RULE NO.: R161-16.01

NOTICE OF PROPOSED RULE

R161-16.01: Proposed revision to the Standards Manual Section

STANDARD NO.
511S-1

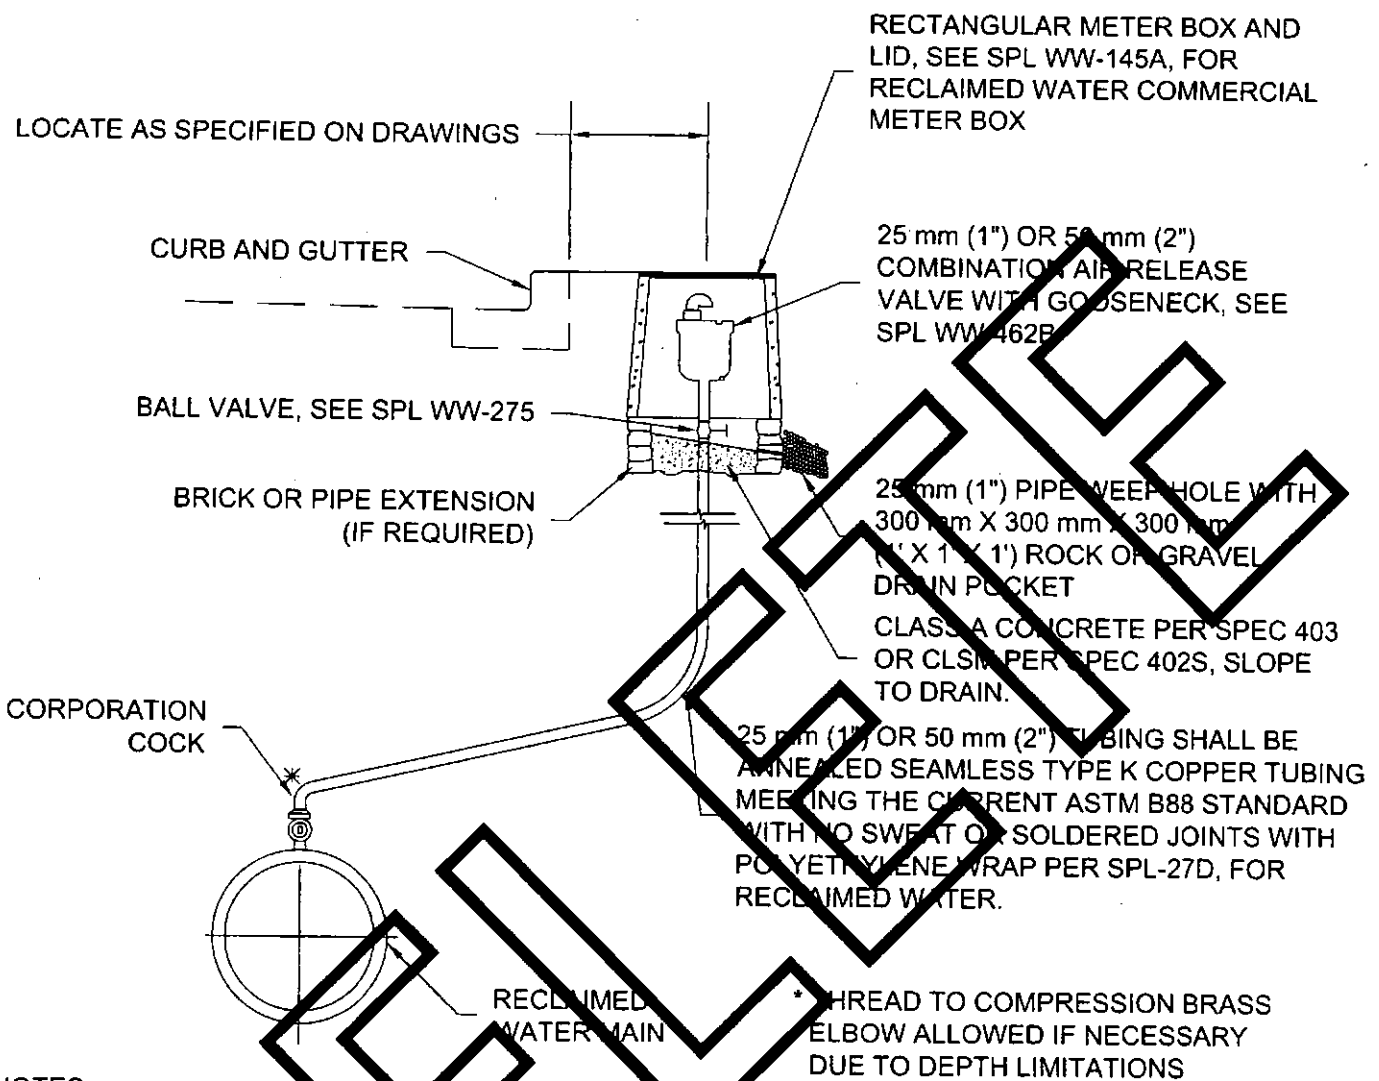
- **511S-1** 25 mm (1") - 50 mm (2") Vented Air Release Valve Installation (Type 1) – Delete
- **511S-1BR** Reclaimed Water Connection 25 mm (1") or 50 mm (2") Reclaimed Water Automatic Air Release Valve – Delete

- **511-AW-04** Air Release and Air/Vacuum Valve – New Detail and New Number
 - Combine 511S-1, 511S-1BR, 511S-2, 511S-3 and 511S-3B into one Standard
- **511-AW-05** Automatic Flush Valve – New Detail and New Number

511S-2

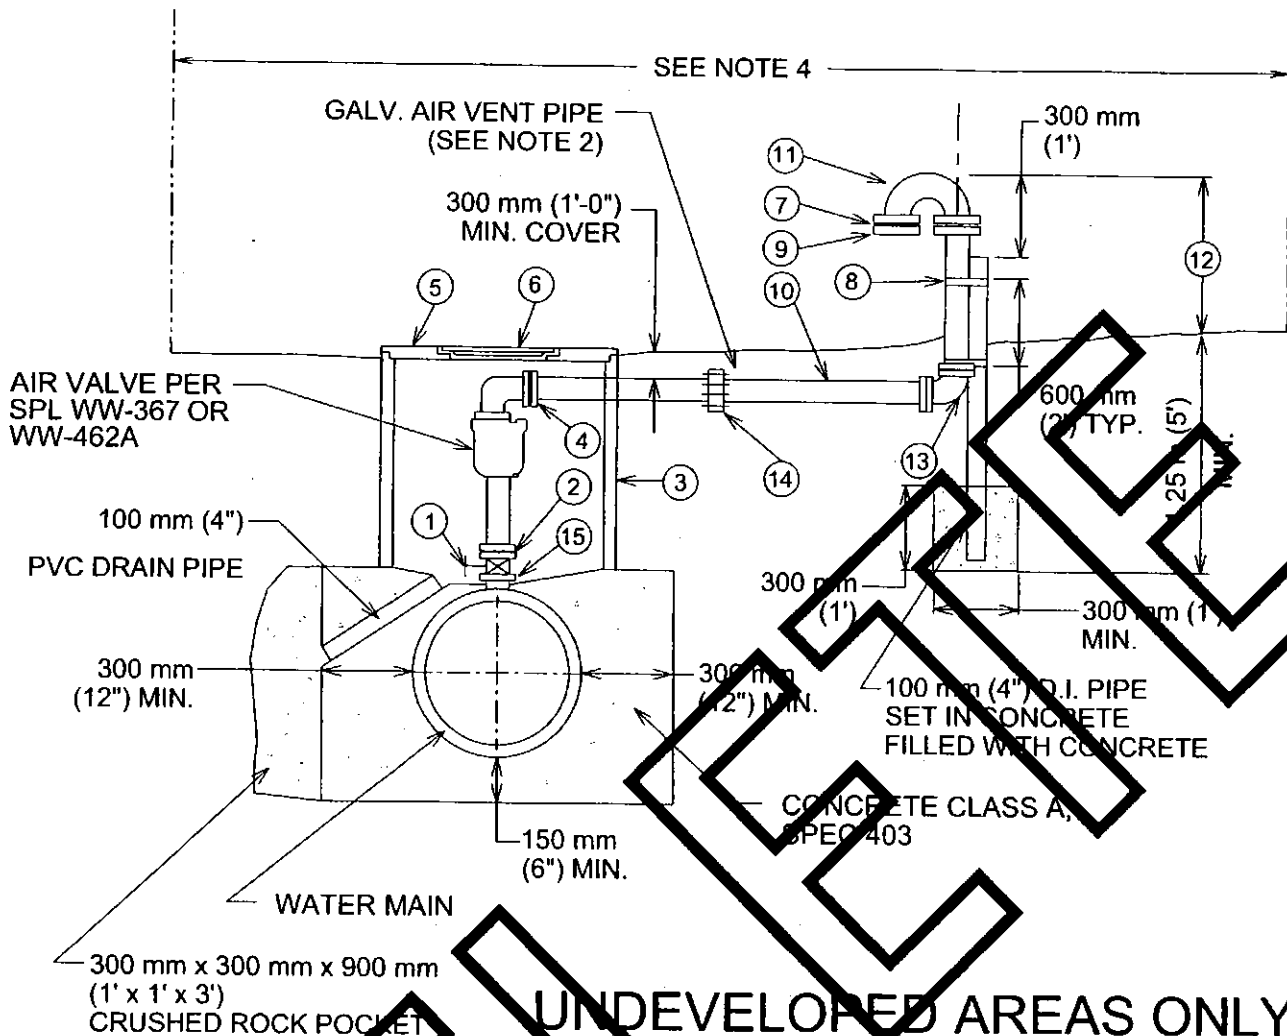
- **511S-2** Type II-76 mm (3") or Larger Vented Air/Vacuum Valve Installation – Delete
- **511S-3** Type III-76 mm (3") or Larger Vented Air/Vacuum Valve Installation – Delete

511S-3B

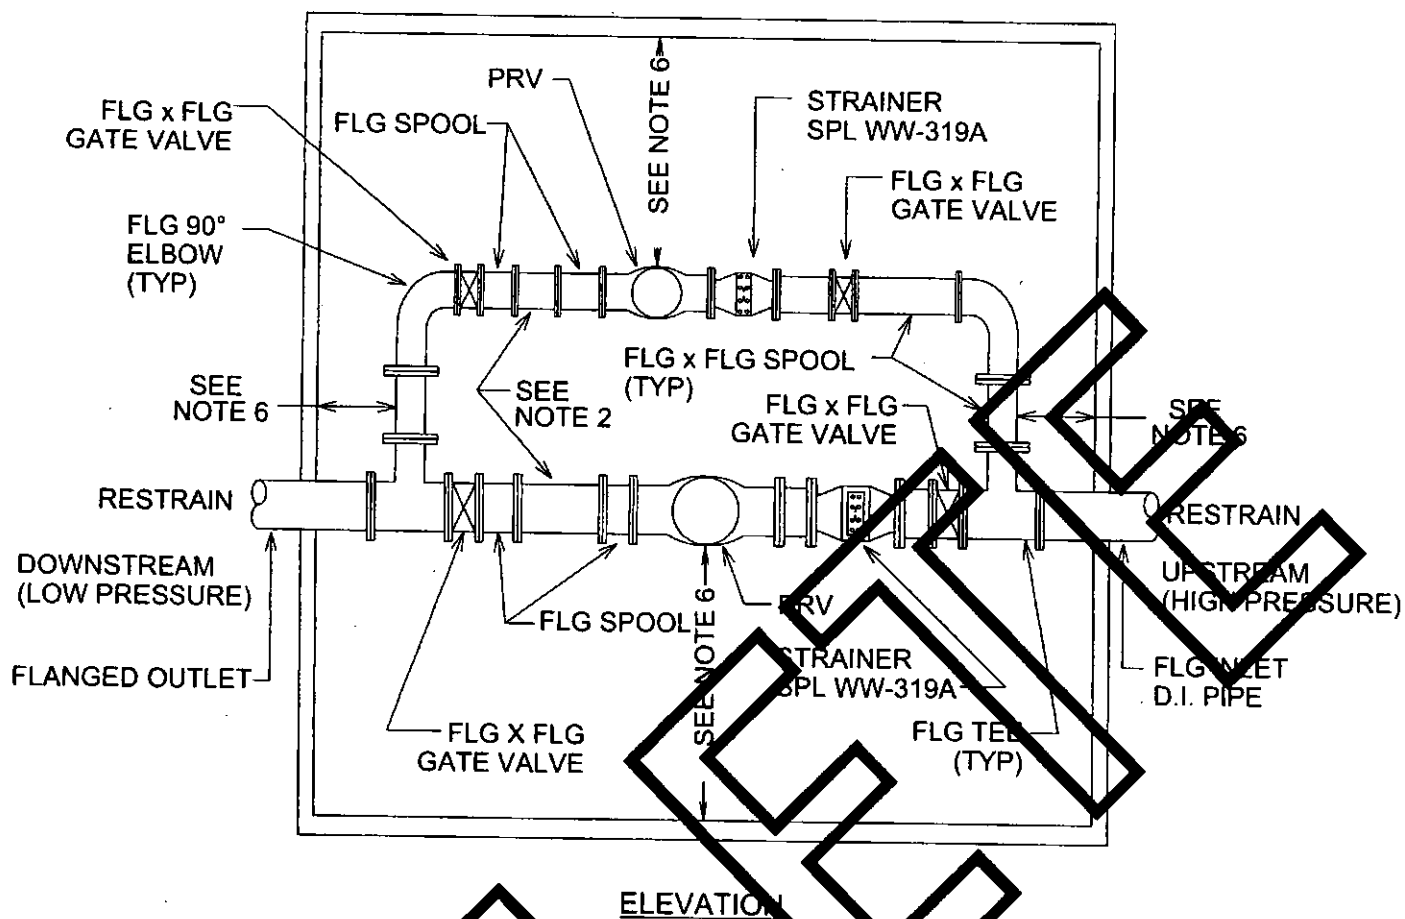
- **511S-3B** Type III-76 mm (3") or Larger Non-Vented Air/Vacuum Valve Installation – Delete
- **511S-5** Dual PRV Installation Guideline - Delete
- **511S-7** Typical Gate Valve 100 mm—600 mm (4"—24") – Delete

CITY OF AUSTIN WATER AND WASTEWATER UTILITY		TYPICAL BUTTERFLY VALVE 900 mm (36") AND LARGER	
RECORD COPY SIGNED BY KATHI L. FLOWERS	9/23/02 ADOPTED	THE ARCHITECT/ENGINEER ASSUMES RESPONSIBILITY FOR APPROPRIATE USE OF THIS STANDARD.	STANDARD NO. 511S-8

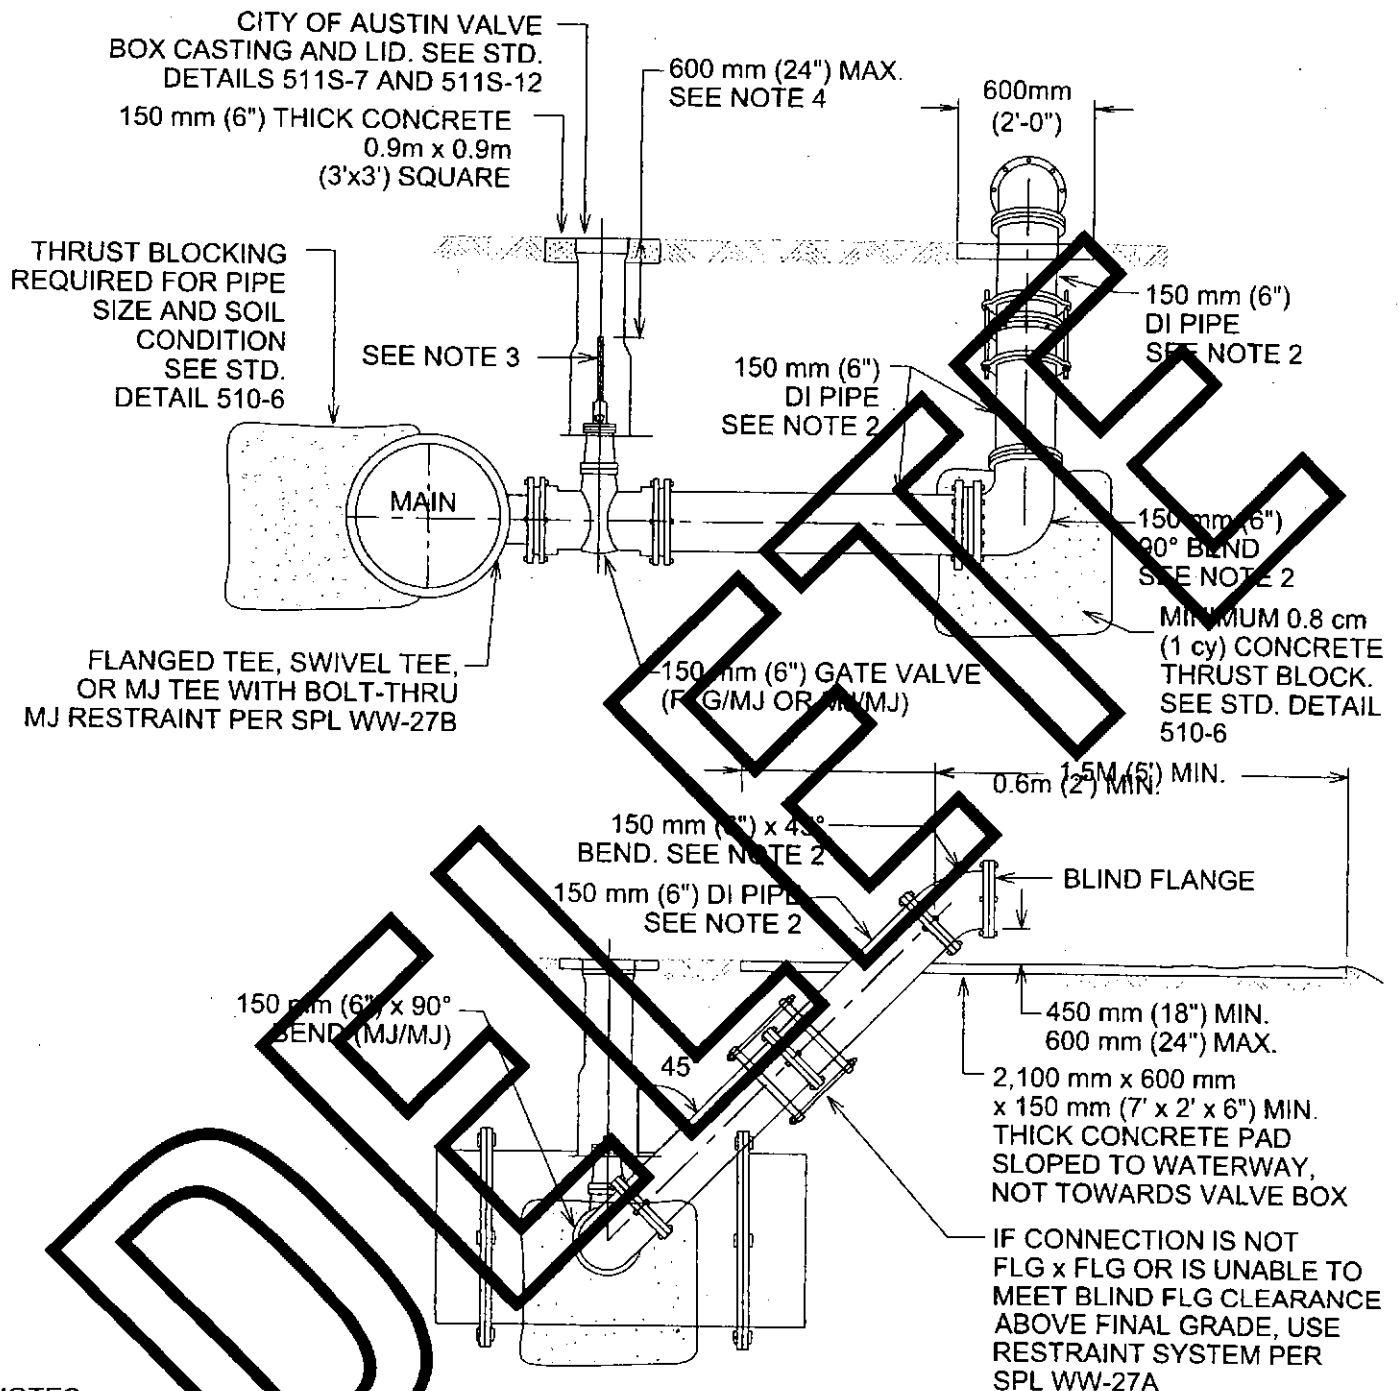
- **511S-8** Typical Butterfly Valve 900 mm (36") and Larger – Delete
- **511S-9A** Drain Valve Installation - Delete
- **511S-10** Debris Cap Installation - Delete

511-11

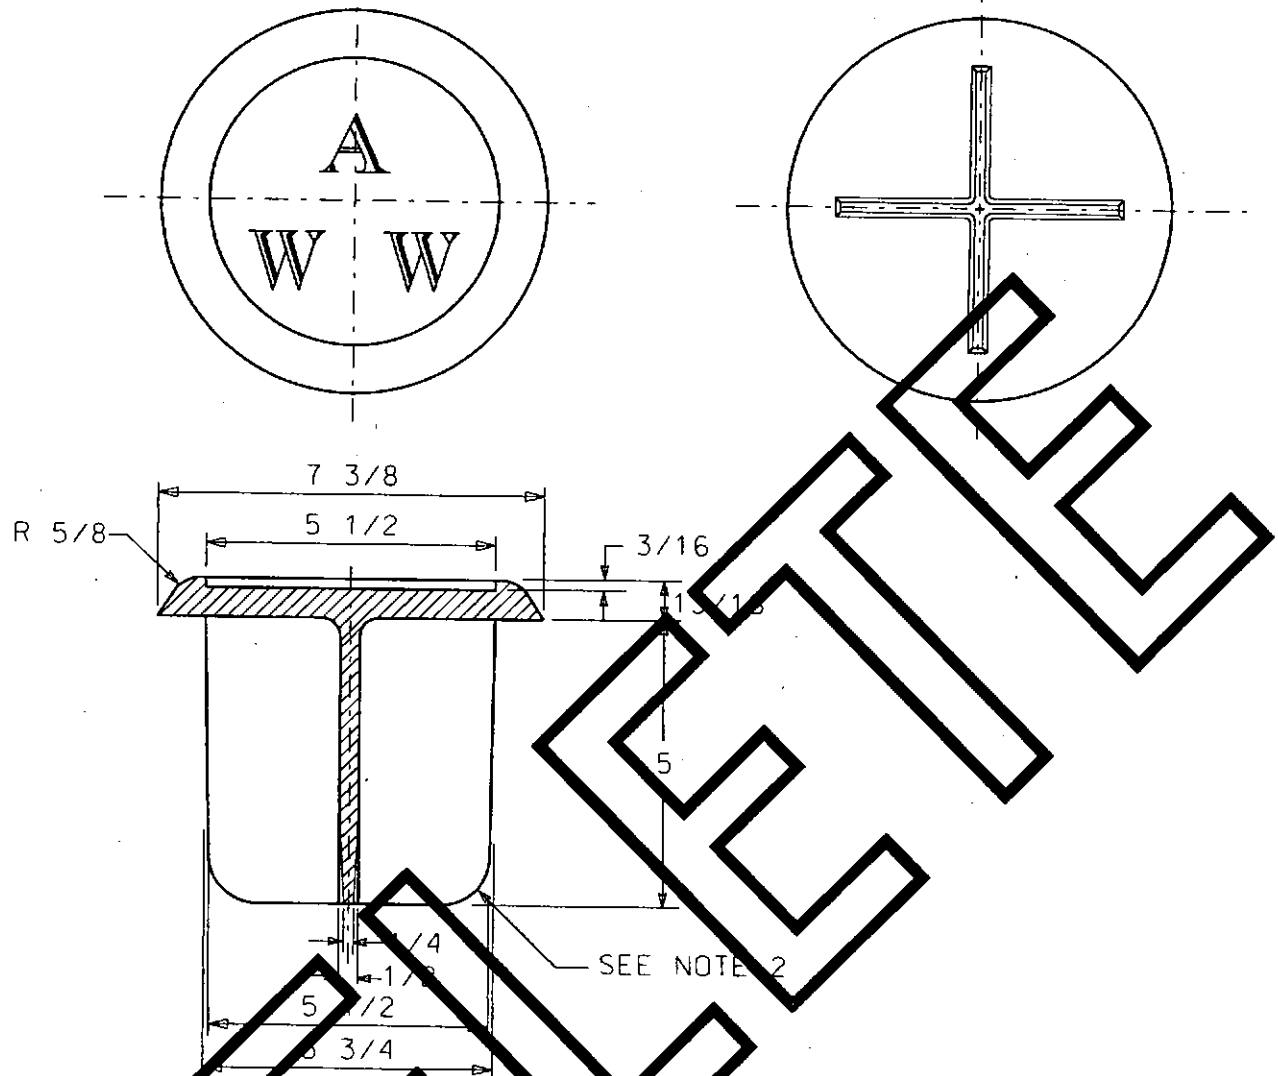
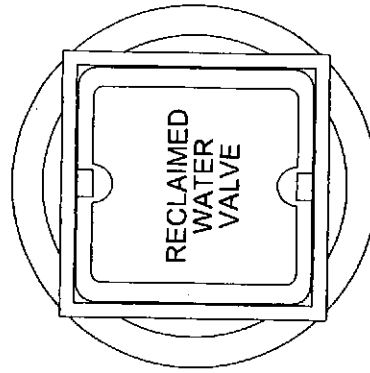
- **511-11** Valve Box Casting C-3 Lid – Delete
- **511S-11R** Reclaimed Water Connection Valve Box and Cover - Delete
- **511S-12** Valve Box Casting C-7 Lid – Delete

- **511-20** Automatic Flush Valve - Delete
- **511-AW-01** Typical Gate Valve 4" – 16" – New Detail and New Number
 - Combine 511S-7, 511-11, 511S-11R, 511S-12, 511-13A, B & C, 511S-14, 511S-15 and 511S-16 into one Standard

511S-13A

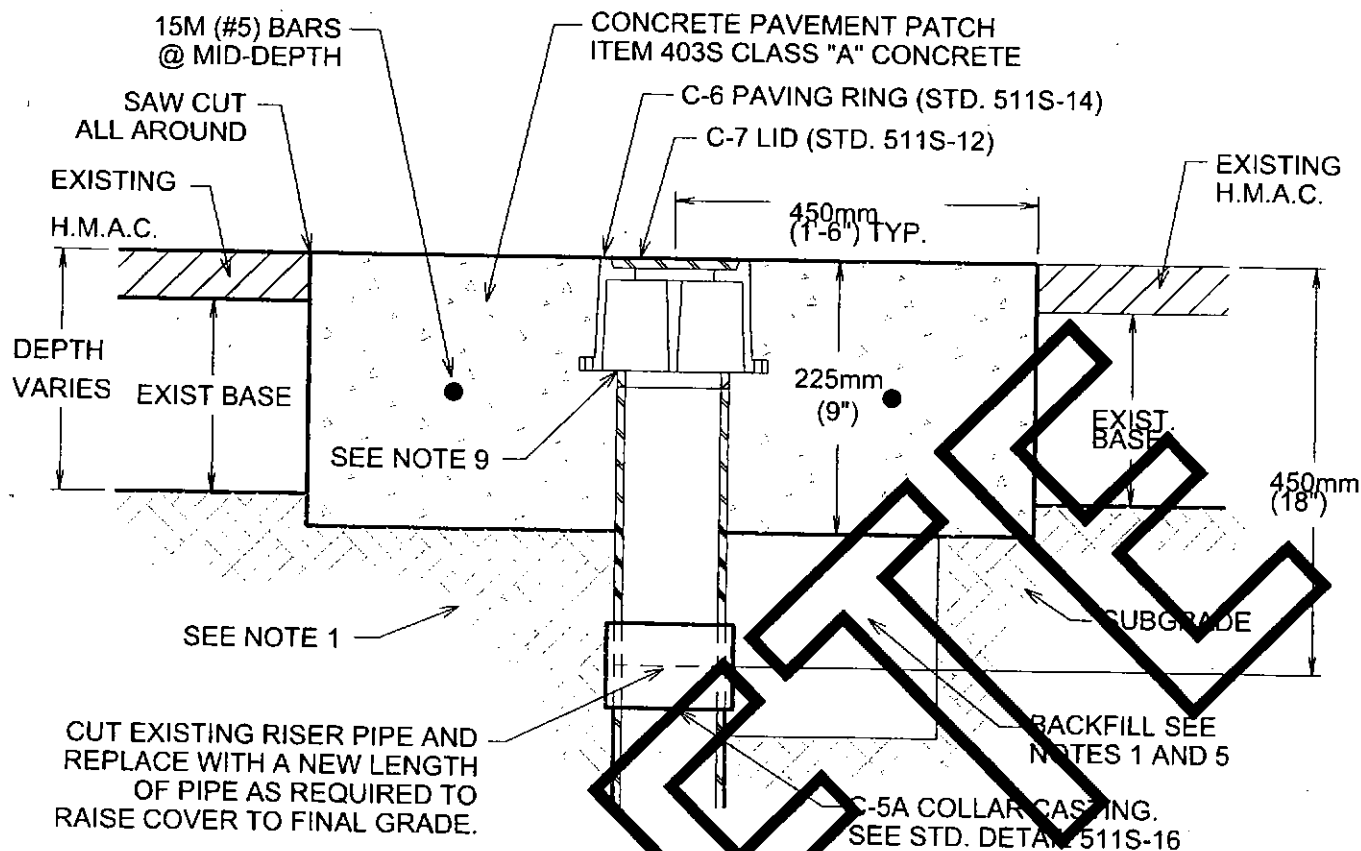
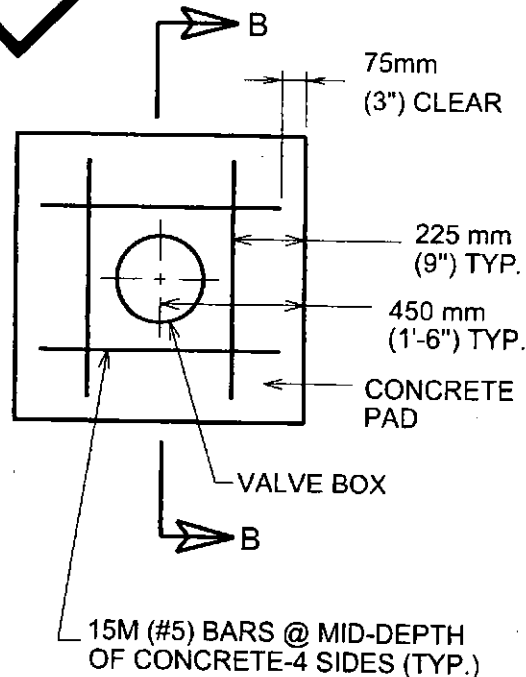
- **511S-13A** Water Valve Box Adjustment to Grade w/Full Depth Concrete – Delete
- **511S-13B** Water Valve Box Adjustment to Grade w/Concrete and H.M.A.C. – Delete

STANDARD NO.
511S-13C

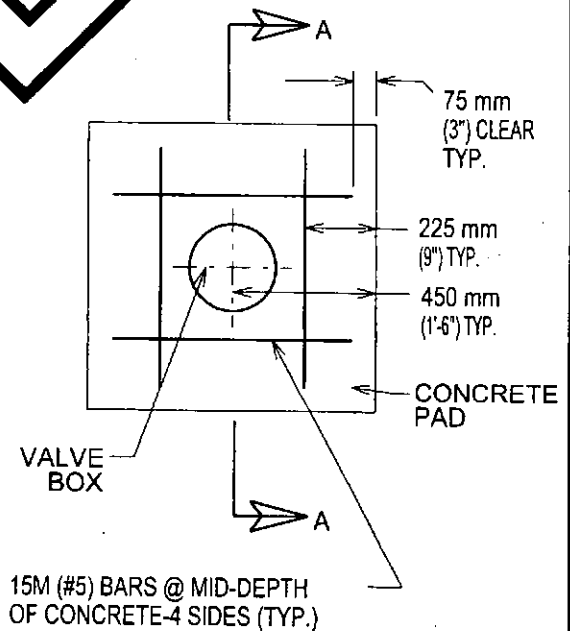
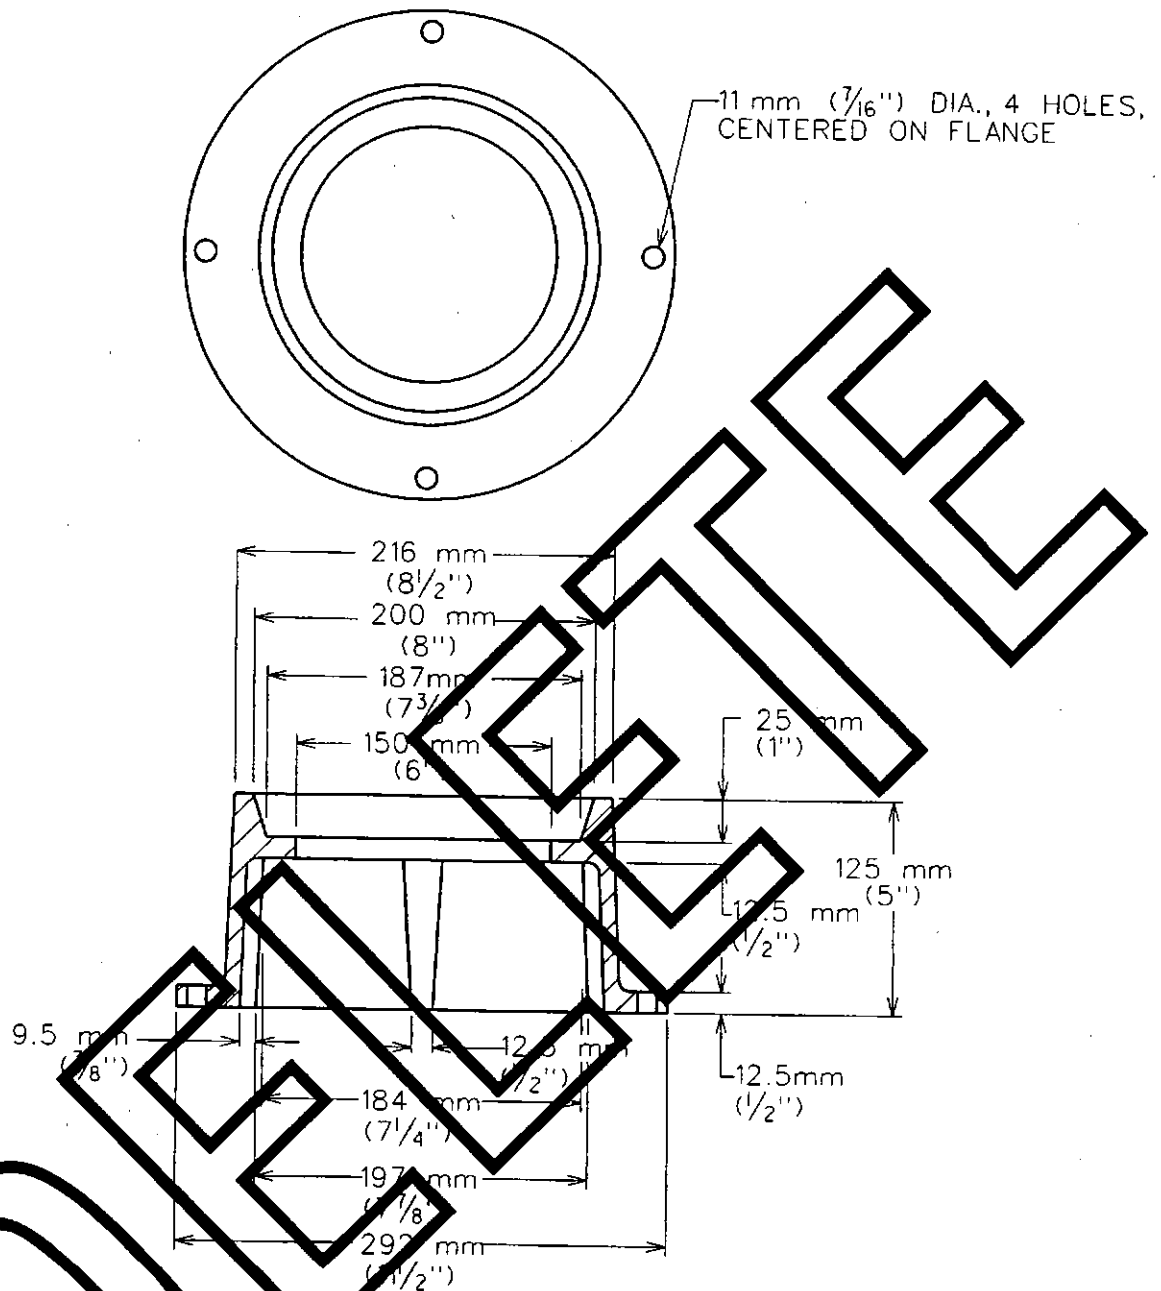
- **511S-13C** Water Valve Box Concrete Pad in Unpaved Area – Delete
- **511S-14** Valve Box Casting C-6 Paving Ring - Delete
- **511S-15** Valve Box Casting Base – Delete
